Rezoning Transportation Analysis

Petition Number: 2023-027

General Location Identifier: 12506201, 12506202

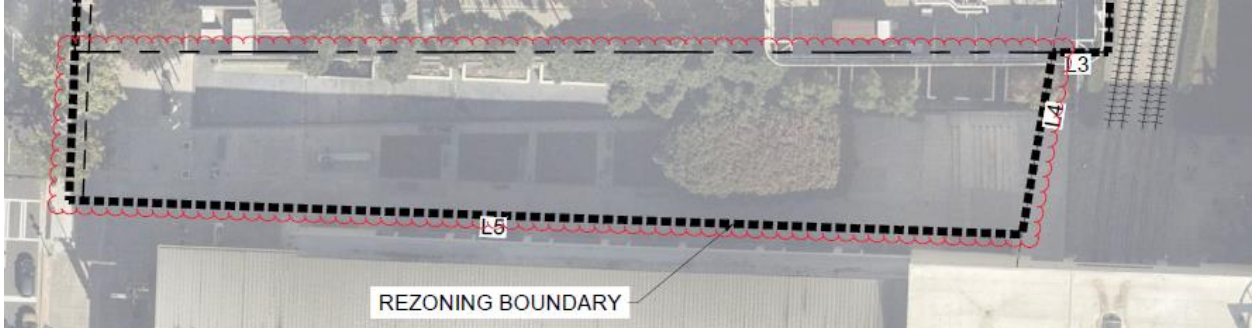
~~9. OUTSTANDING COMMENT FROM 6-28-23: Phasing plan needs to be clarified so CDOT can review how the infrastructure will be phased during construction.~~

~~Add a conditional note specifying “All transportation improvements will be approved and constructed before the site’s first building certificate of occupancy is issued. The petitioner may phase transportation improvements if said improvements and phasing are explicitly described in site plan notes.”~~

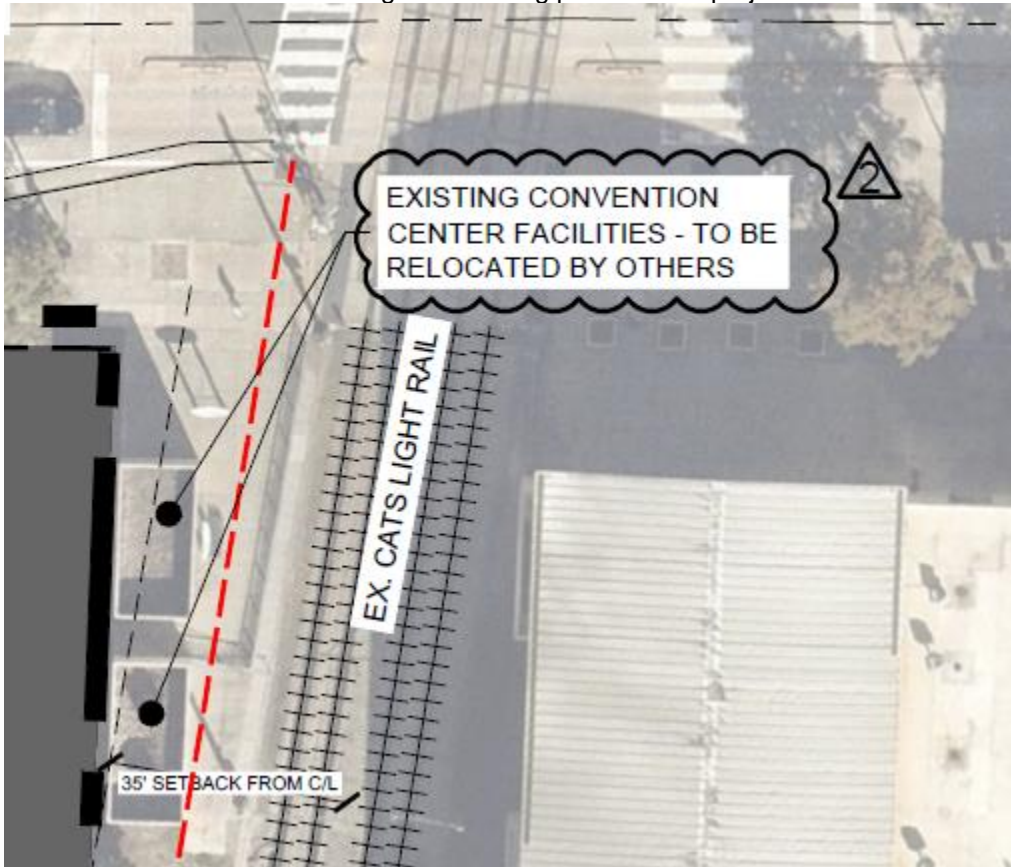
Revise site plan to add more clarity to the area below that is outside of the property line but part of the rezoning. Is this public ROW?

11. **OUTSTANDING COMMENT FROM 7-27-23:**

Remove callout and conditional note regarding relocation by others for construction of Rail Trail. This should be coordinated during the rezoning phase of the project.

Clarifying Comment FROM 8-30-23:

Remove callout on site plan referencing relocation of convention center facilities by others.

4. Rail Trail:

- a. The Petitioner will construct the Rail Trail contingent upon the Convention Center removing the utility boxes from the corridor and the Convention Center constructing the
